POWER PLANT - ENGINE - RESET EDUCTOR SYSTEM WITH REVISED HARNESS AND CLIPPING -
CATEGORY CODE 6 - MOD.ENG-71-0150

This Service Bulletin introduces a revised eductor system with improved operation capabilities and reliability.

V2500-ENG-71-0150

Part schematic view of harness loom A - Before and after alteration
Fig.1

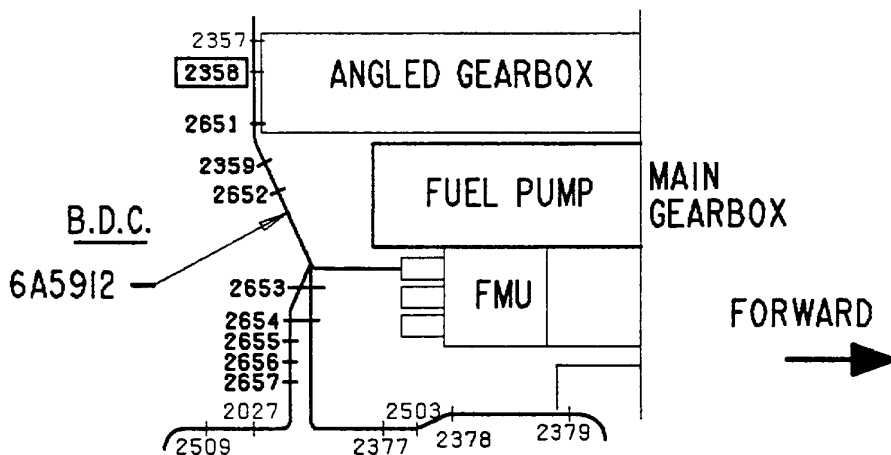
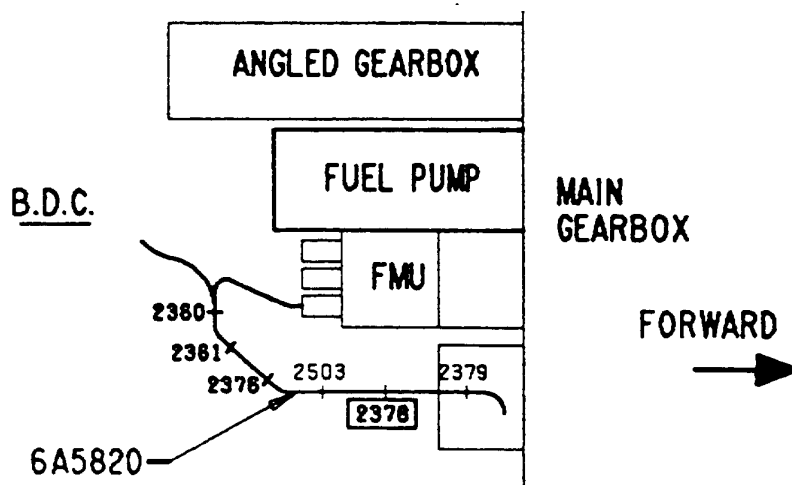
(8) A new harness loom 'A' assembly to replace the existing assembly.

The new harness assembly is identical to the existing harness except for the break out position for the FMU connector. The distance from the datum position D2358 to the new break-out position is reduced from 15.250 in. (387,35mm) to 8.250 in. (209,55mm).

Existing harness assemblies can be reworked as instructed in the accomplishment instructions to the revised break point and re-identified to the modified standard.

Part schematic view of harness loom B - Before and after alteration
Fig.2

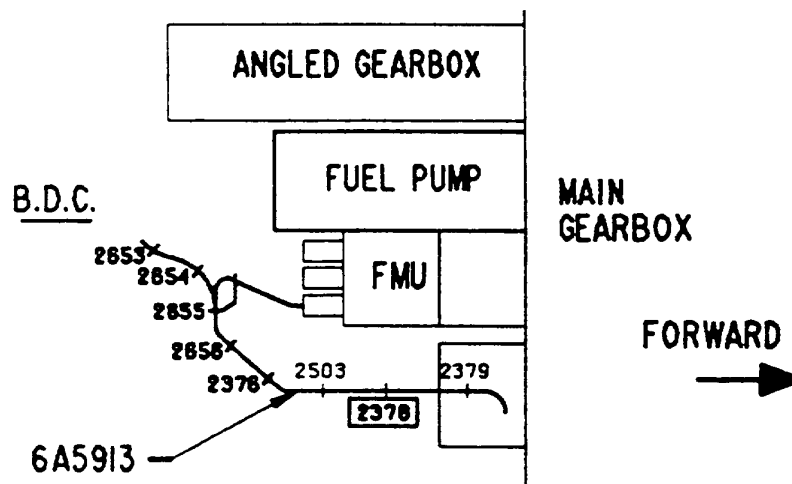
(9) A new harness loom 'B' assembly to replace existing assembly.

The new harness assembly is identical to the existing harness except for the breakout position for the FMU connector. The distance from the datum position D2378 to the new break-out position is reduced from 13.000in. (330,20mm) to 7.000in. (177,80mm). Existing harness assemblies can be reworked as instructed in the accomplishment instructions to the revised break point and re-identified to the modified standard.

Schematic view of raceway - Before and after alteration
Fig.3

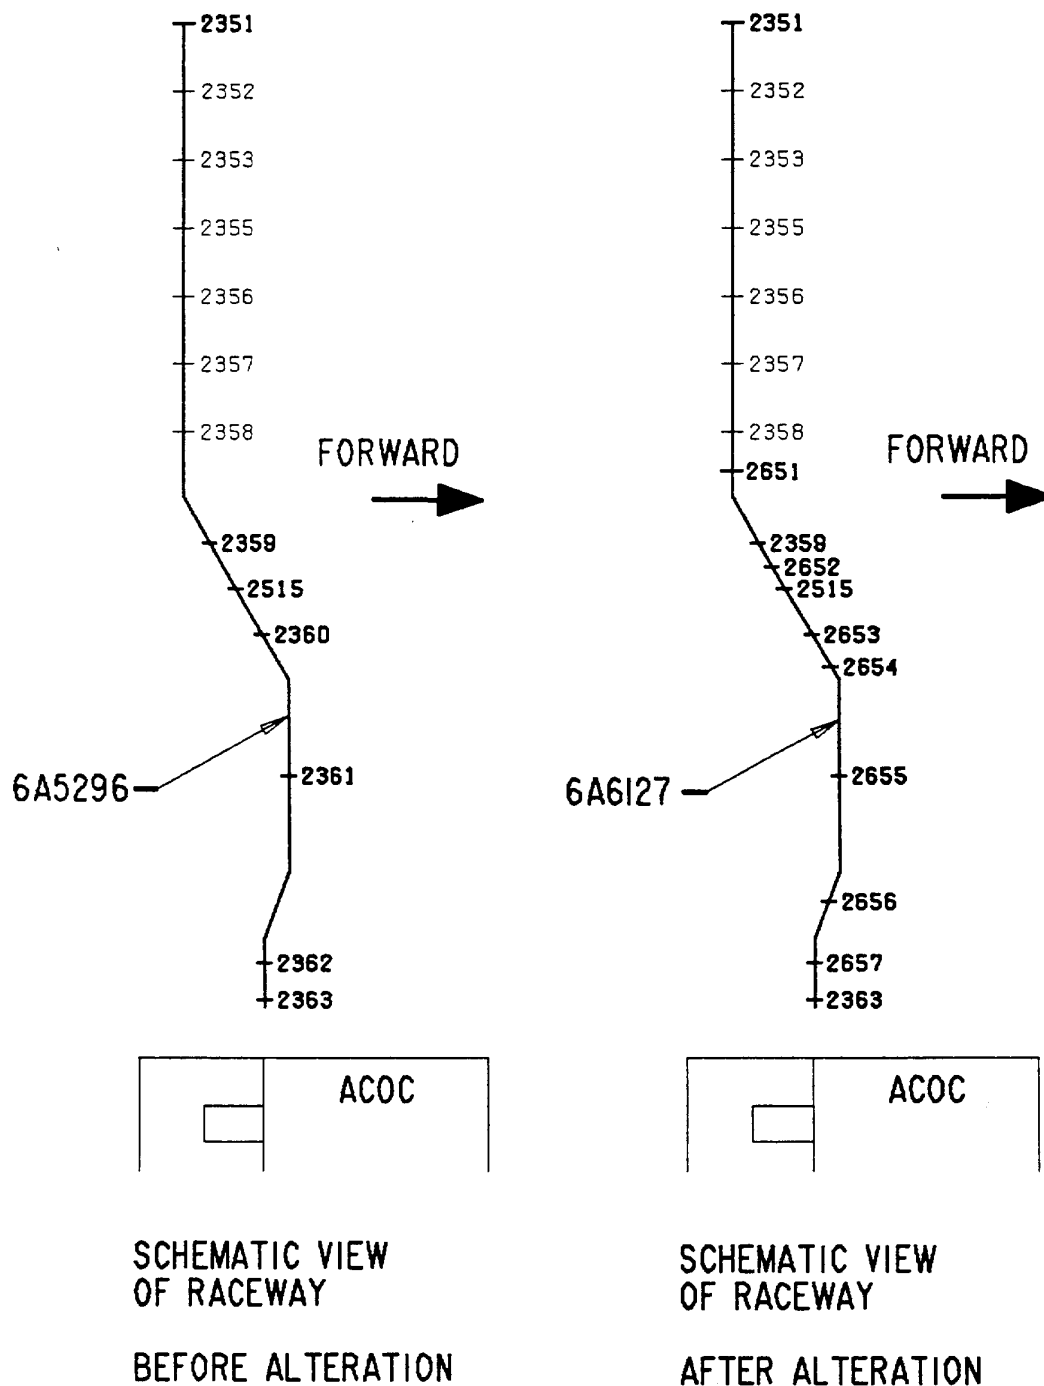
- (6) A new raceway which runs from clipping point 2351 to clipping point 2363 to replace the existing raceway.

The new raceway has been rerouted to accommodate the new eductor system and 4 off additional J-blades to support new clipping points to give a total of 13 clipping lugs.

- (41) Assemble clipping points 2352, 2353, 2355, 2356, 2357 and 2358 using the material removed at step (9) on to the new 6A6127 raceway. Torque the bolts at each clipping point to 36 to 45 lbfin (4 to 5 Nm). Refer to Figure 3.

Schematic view of fuel tubes - Before alteration
Fig.5

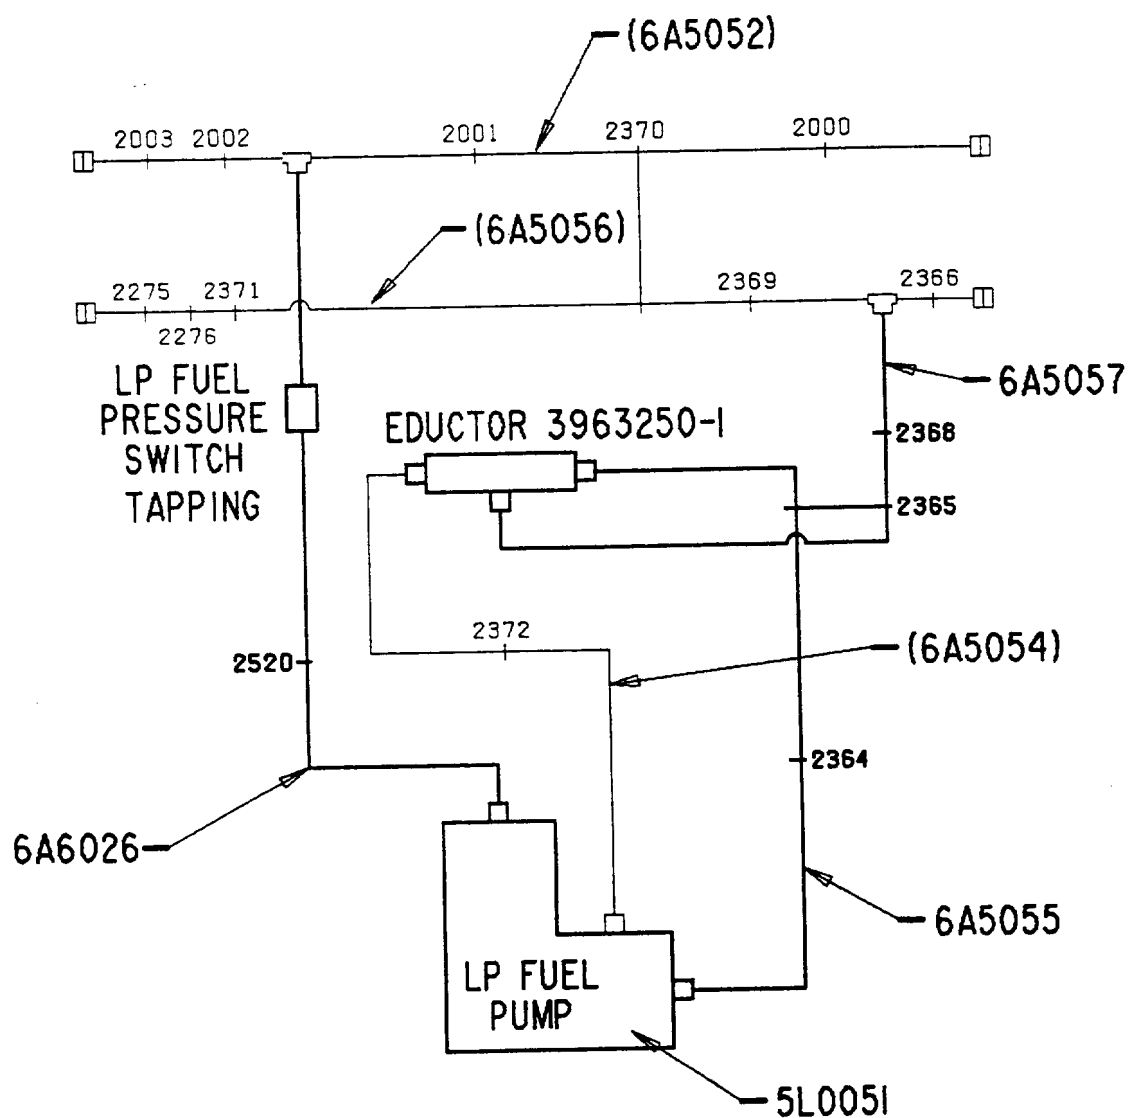
- (2) A new pipe assembly which runs from the fuel bridle pipe to the L.P. pump inlet to replace the existing pipe assembly. The new pipe assembly has been rerouted to accommodate the new eductor system hardware and an end fitting altered.

- (3) A new pipe assembly which runs from the eductor outlet to a tapping on the new end fitting on the pipe assembly above to replace the existing pipe assembly.

- (4) A new pipe assembly which runs from the fuel bridle pipe to the eductor inlet to replace the existing pipe assembly. The new pipe assembly is similar to the existing except for slight rerouting and an additional inline clipping lug for clipping point 2648.

Schematic view of fuel tubes - After alteration
Fig.6

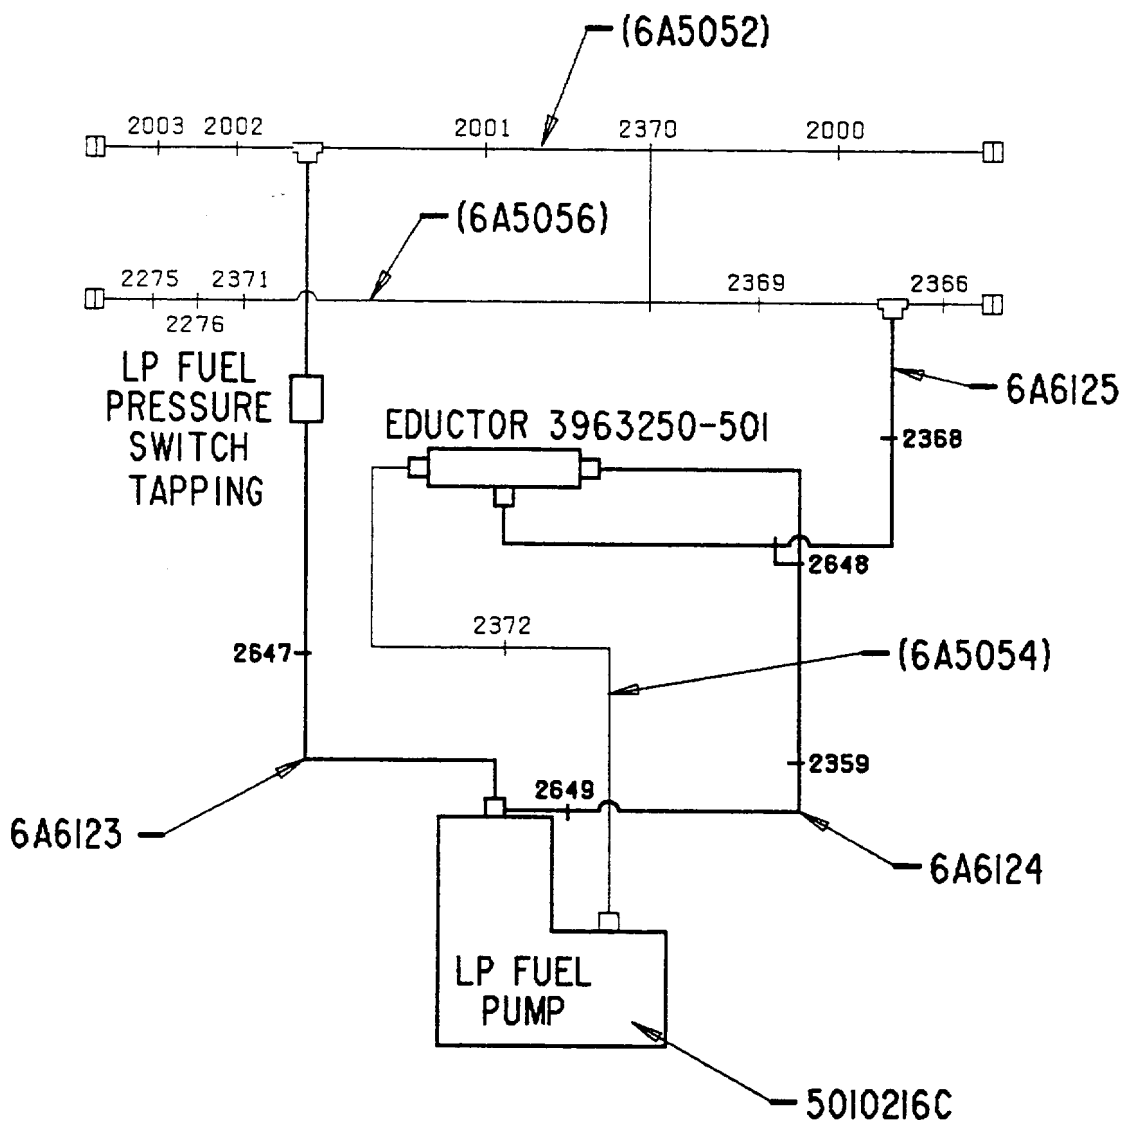
The new pipe assembly is supported by a new clipping point 2647 on a new bracket fitted on the rear face of flange FE at the bolt holes 183.75 degrees and 186.25 degrees clockwise from TDC. The existing bracket for clipping point 2520 at this position is deleted.

The new pipe assembly is supported by an amended clipping point 2359 which is supported on a new raceway and new clipping point 2648 which is supported by an inline clipping lug on the pipe assembly below and 2649 which is supported from a modified bracket fitted off the end fitting on the L.P. fuel pump of the pipe assembly above, this bracket also supports clipping point 2381. Clipping points 2364 and 2365 which supported the old pipe assembly are deleted.

The new pipe assembly is supported by an amended clipping point 2368.

PART SCHEMATIC VIEW
OF OIL SCAVENGE TUBESPart schematic view of oil scavenge tubes - Before and after alteration
Fig.7

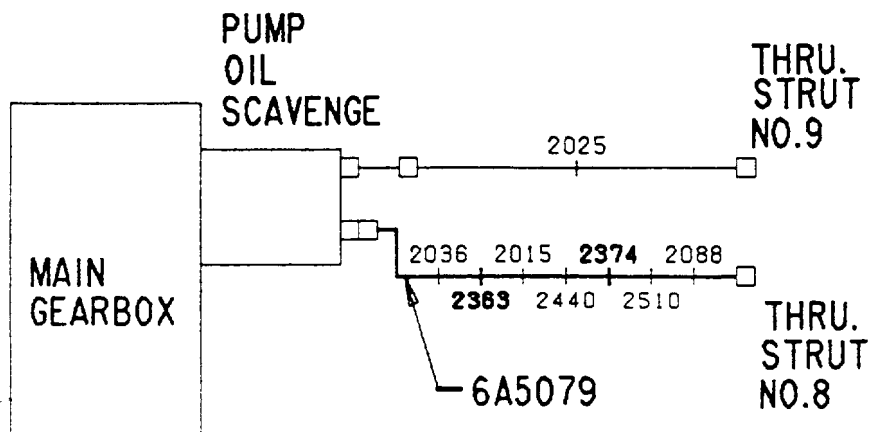
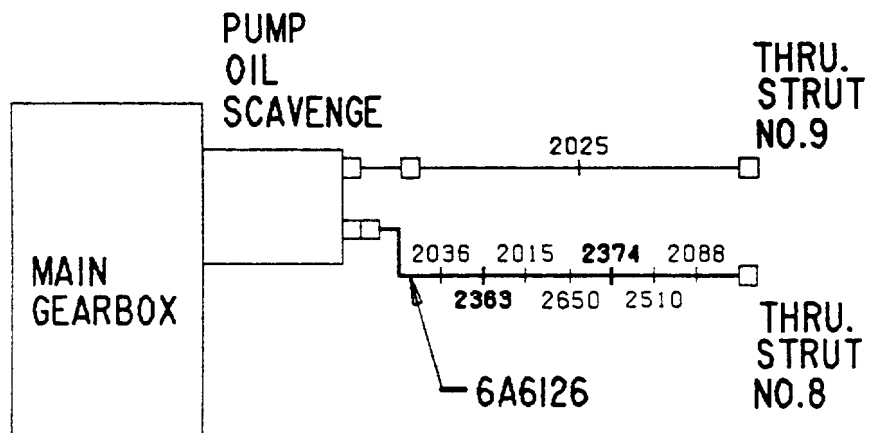
- (5) A new pipe assembly which runs from the No.8 strut to the oil scavenge pump to replace the existing tube assembly.

The new pipe assembly is identical to the existing except for the deletion of the J-blade for clipping point 2440 which has been deleted and an additional J-blade for new clipping point 2650 for support.

- (22) Lubricate a new MS9967-218 sealing ring with CoMat 10-077 approved engine oils. Install the sealing ring into the new 6A6126 oil tube and use the three bolts removed in step (11) to install the 6A6126 oil tube on to the scavenge pump. Torque the bolts to 85 to 105 lbfin (10 to 12 Nm). Refer to Figure 7.

- (23) Lubricate a new AS43013-123 sealing ring with CoMat 10-077 approved engine oils. Install the sealing ring into the new 6A6126 oil tube and use the three bolts removed in step (11) to install the 6A6126 oil tube on to the fan case. Torque the bolts to 85 to 105 lbfin (10 to 12 Nm). Refer to Figure 7.

Clipping point 2351 - Before and after alteration
Fig.8

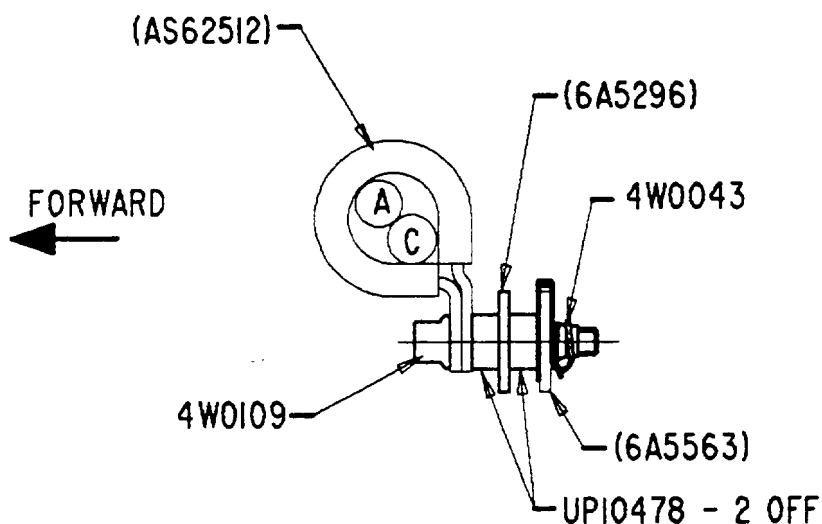
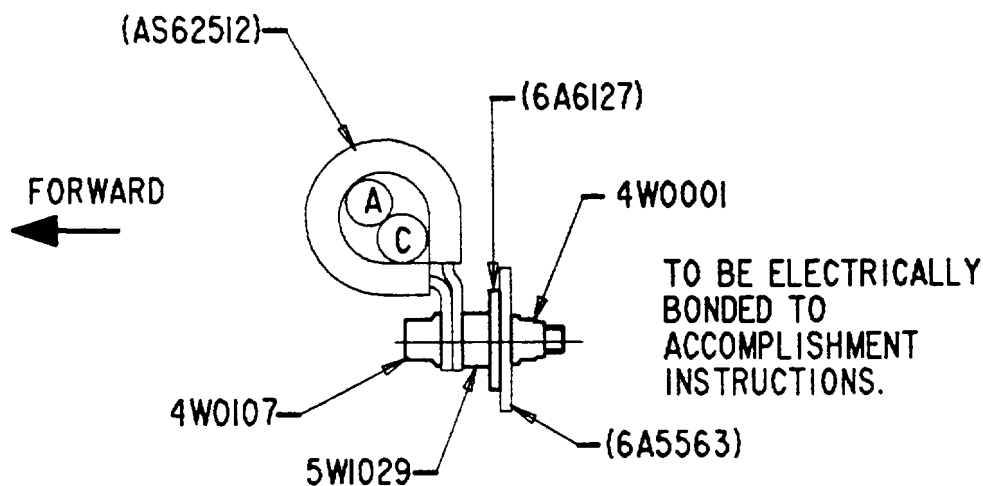
- a) Existing clipping points 2360, 2361, 2364, 2365 and 2520 are deleted.
- b) Existing clipping points 2351, 2359, 2363, 2368, 2374, 2376, 2381 and 2515 are amended.
- c) New clipping points 2647, 2648, 2649, 2651, 2652, 2653, 2654, 2655, 2656 and 2657 are added.

- (24) Clean all mating faces with CoMat 01-002 inhibited and stabilized trichloroethane and install the 6A6127 raceway on to the bracket at clipping point 2351 using the new bolt, spacer and nut, and the existing clip. Torque the bolt to 36 to 45 lbfin (4 to 5 Nm). Refer to Figures 3 and 8.

View on arrow AD - Before alteration
Fig.24A

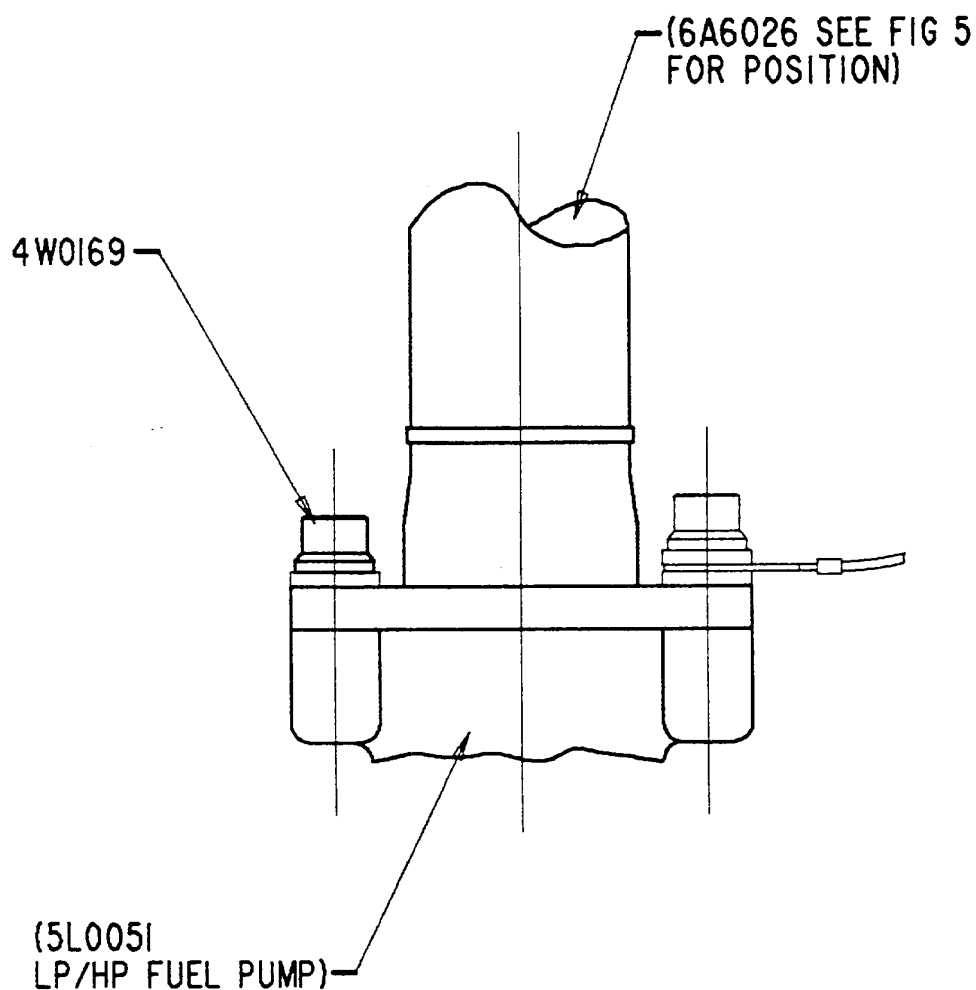
The new LP/HP fuel pump is identical to the existing pump except for a fuel tube nipple, previously connected to the eductor system, which is replaced by a plug.

- (28) Remove the MS24392J8 fuel tube nipple and sealing ring from the LP fuel pump housing and discard the sealing ring. Lubricate a new M25988-1-908 sealing ring with CoMat 10-038 petroleum jelly or CoMat 10-060 liquid paraffin. Install the sealing ring and the MS9954-08 plug on to the LP fuel pump housing. Torque the plug to 110 to 150 lbfin (12,4 to 16,9 Nm). Safety the plug with CoMat 02-147 lockwire. Refer to Figures 23 and 24.

Rework of existing harness looms 'A' and 'B'
Fig.25

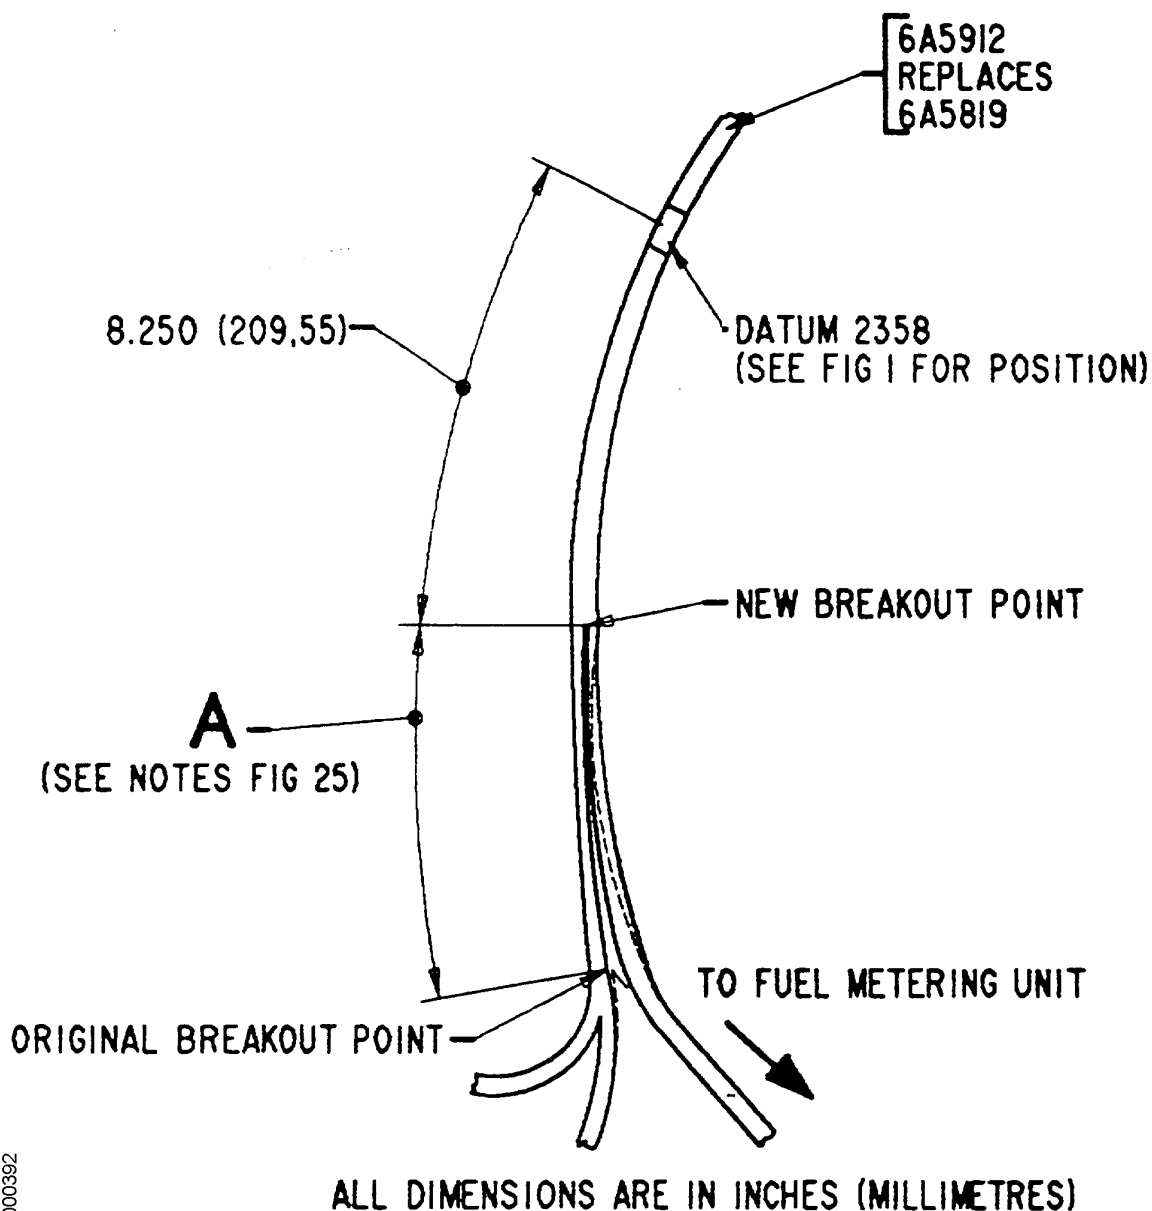
1. RECORD ALL EXISTING TIE POSITIONS INCLUDING BREAKOUT POINTS
AT POSITIONS **A** (LOOM A SEE FIG 26) AND **B** (LOOM B SEE FIG 27)
2. CUT TIES AND REMAKE BREAKOUT POINTS AS INDICATED (SEE FIGS 28 AND 29 FOR RETIEING PROCEDURE) USING BRAID MATERIAL PART NUMBER 3100631.
3. RETIE EACH LIMB AT PREVIOUSLY RECORDED POSITIONS UPTO AND INCLUDING ORIGINAL BREAK OUT POINTS (SEE FIG 30 FOR RETIEING PROCEDURE) USING BRAID MATERIAL PART NUMBER 3100631.
4. REMOVE EXISTING IDENTIFICATION.
5. APPLY TWO (2) TURNS OF COMAT 02.148 IN ORIGINAL POSITION AND MARK ON NEW PART NUMBER USING A BLACK BALLPOINT PEN.
